AL295 Series MicroBrite[™] Bar Lights

Change Notice

PCN No: 144

PCN No: 125

AL295

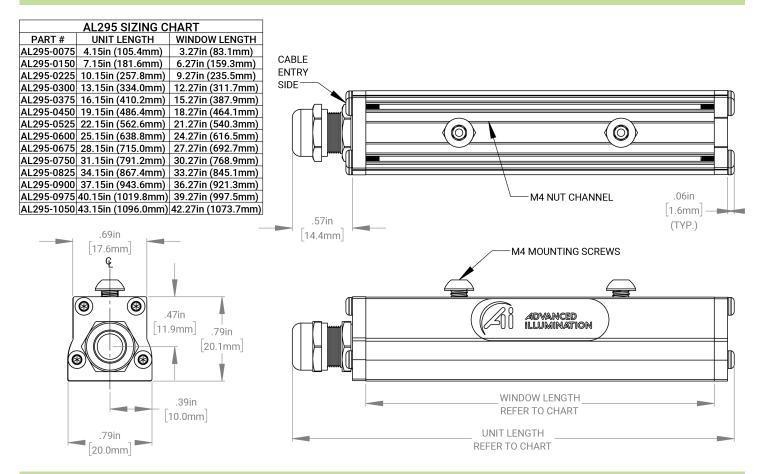
Advanced illumination (Ai) is improving the way we manufacture washdown lights which will change their outward appearance. We will be replacing the black cordstock with clear flowable silicon. This change will provide a more durable finish and will effect the following lights: AL116, AL126, AL143, AL179, AL295, BL128, QM116, QM126, LL174 and SL147.

In an effort to improve our products, Advanced illumination (Ai) will update the LEDs used in the AL295 design. This change will result in a brighter, more uniform light at the same price*. Customers may still buy the current revision of this model until September 2th of 2016. After that time, orders for these products will be converted to their respective AL295 Revison A models.

This LED change will result in additional wavelengths being available: 365nm, 375nm, 385nm, 395nm, 405nm, 470nm, 505nm, 590nm, 660nm, 730nm, and 940nm. Additionally the white LED color temperture will be changing from 6100K to 5500K.
